IEC 61360-1

AMENDMENT 1
2003-12

**Standard data element types with associated
classification scheme for electric components –**

**Part 1:
Definitions – Principles and methods**

Figure 5 – Attributes of the value list for data element type

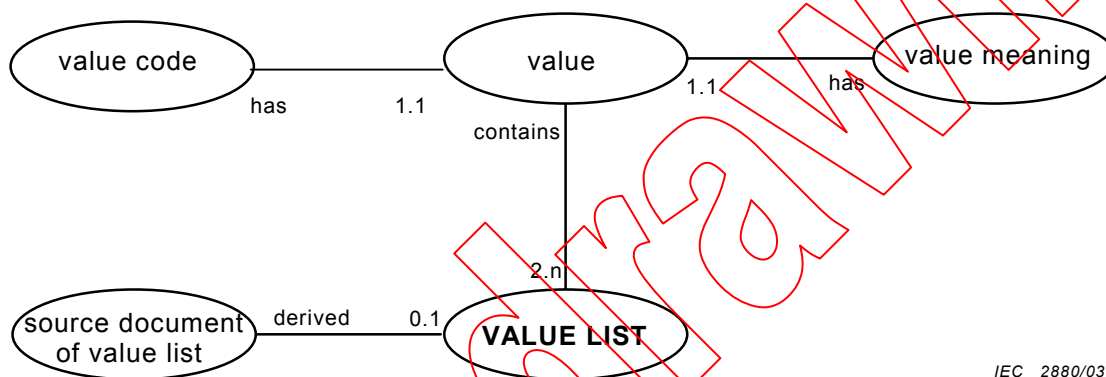
Replace the existing Figure 5 by the following new Figure 5
